Robert A. Young
Federal Bldg

SITE PLAN

A1

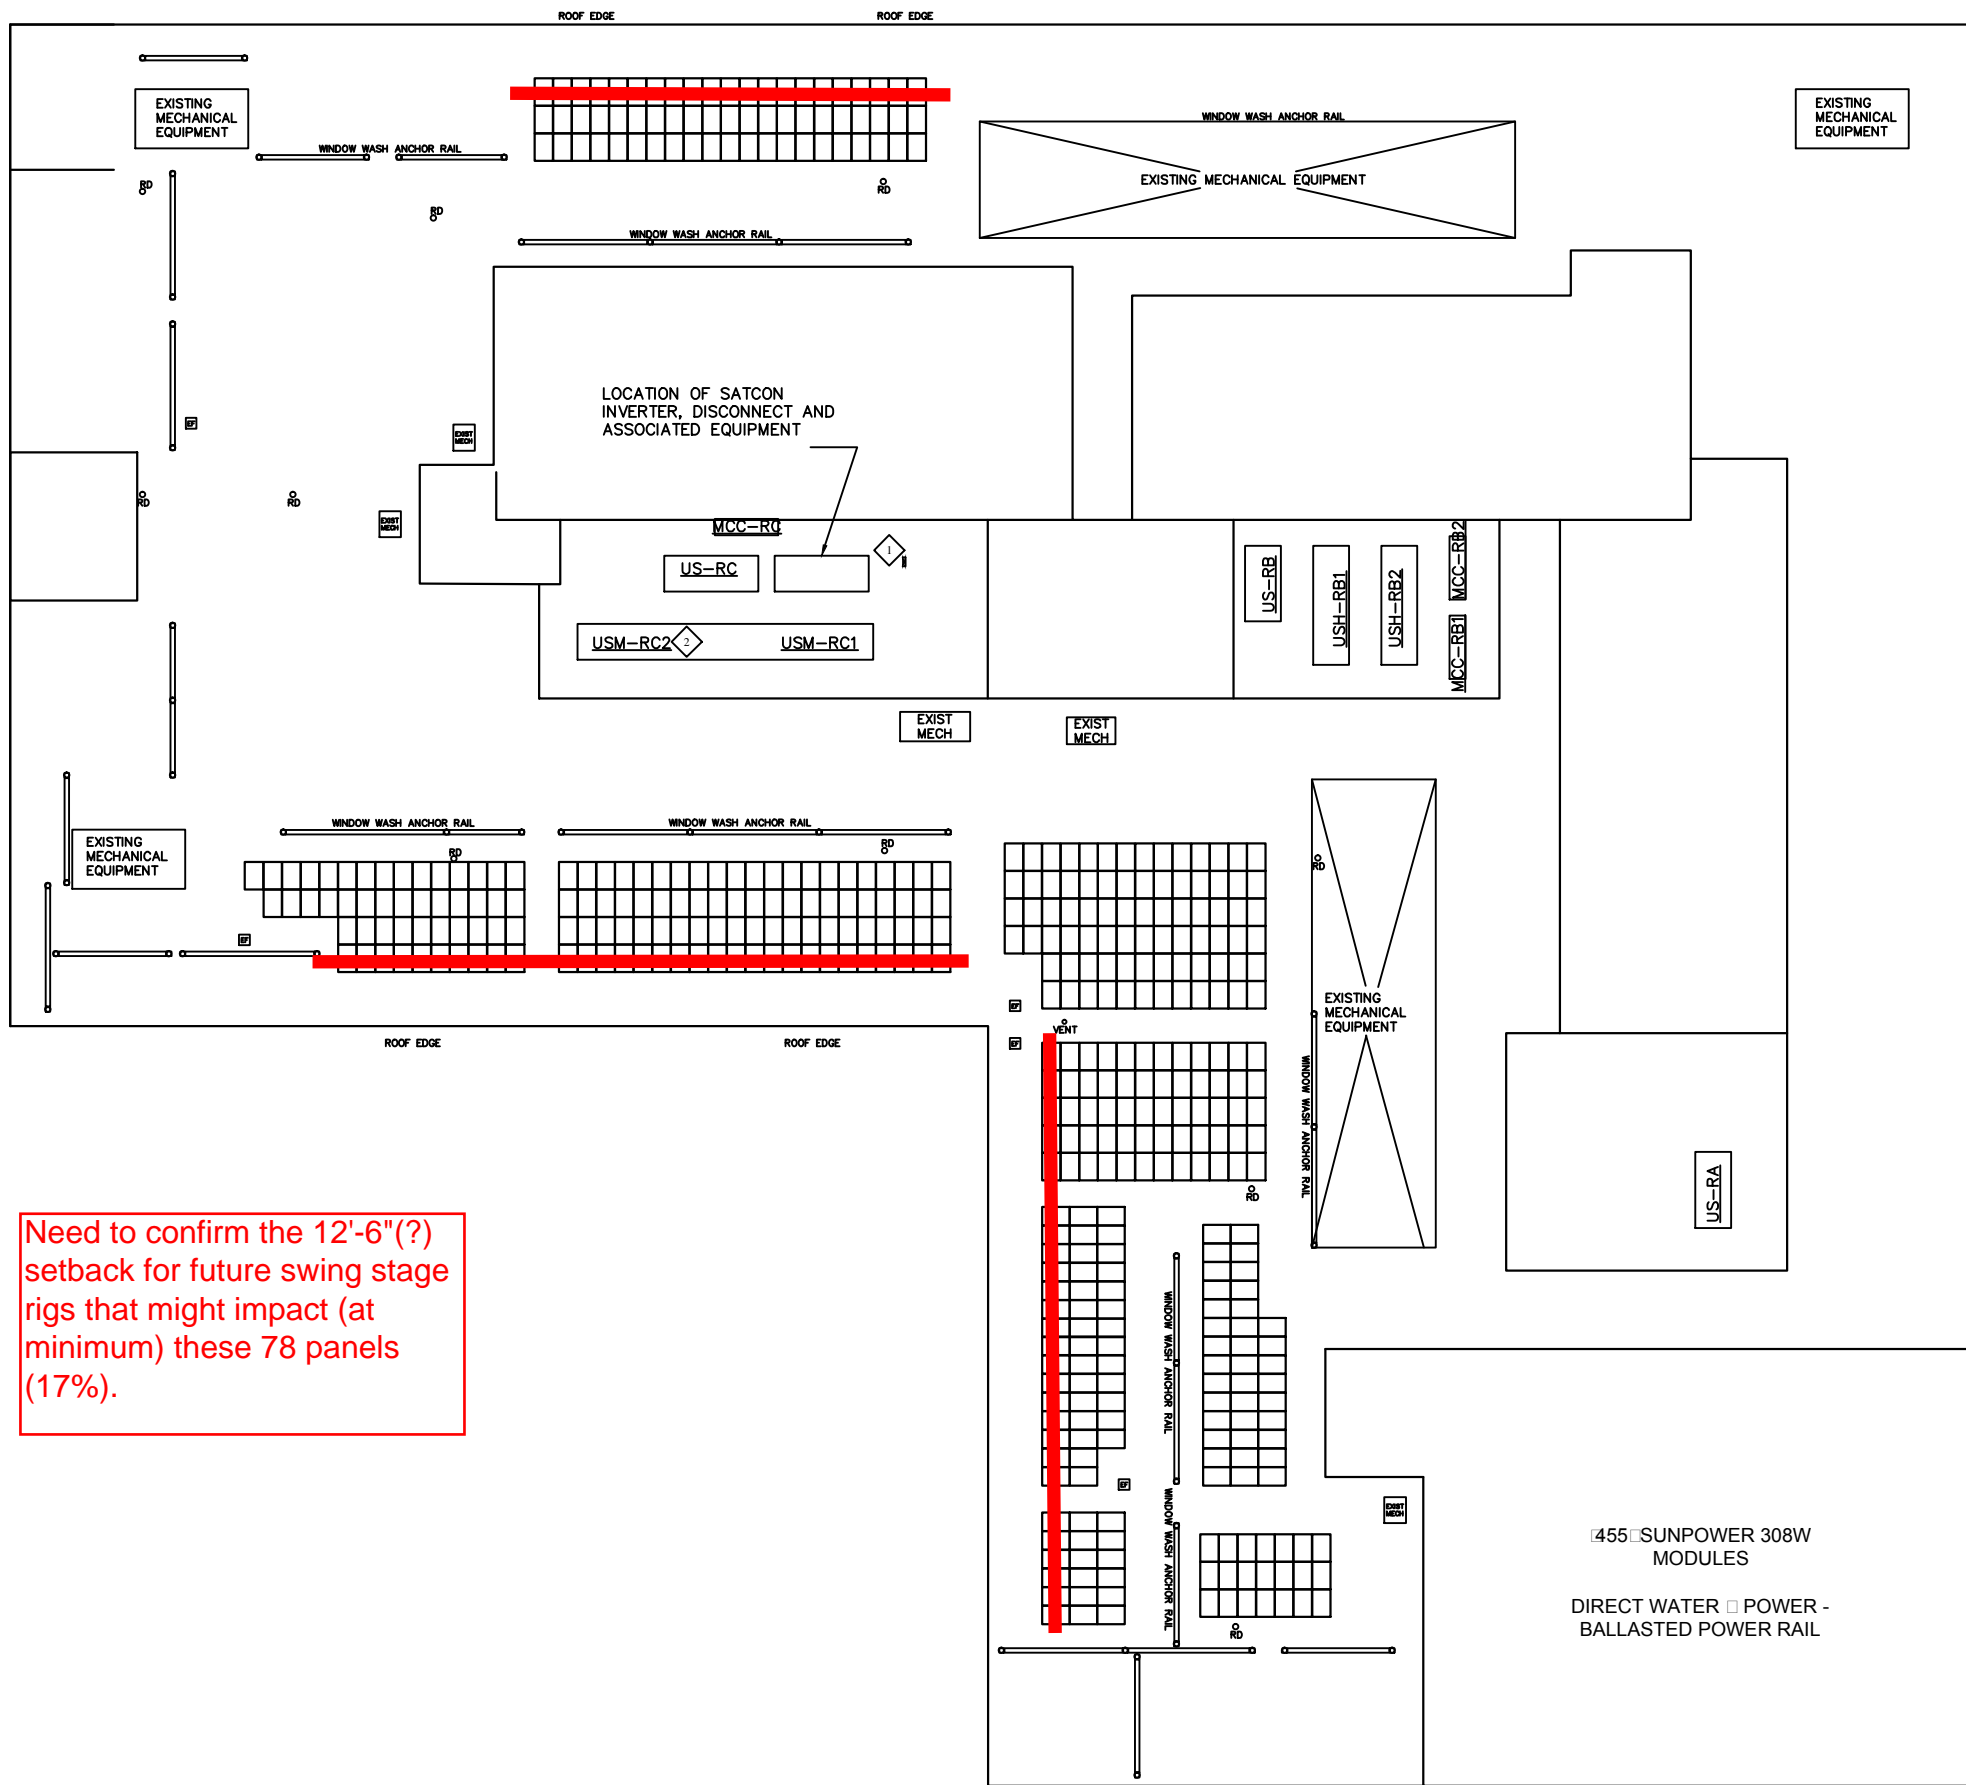
Need to confirm the 12'-6" (?) setback for future swing stage rigs that might impact (at minimum) these 78 panels (17%).
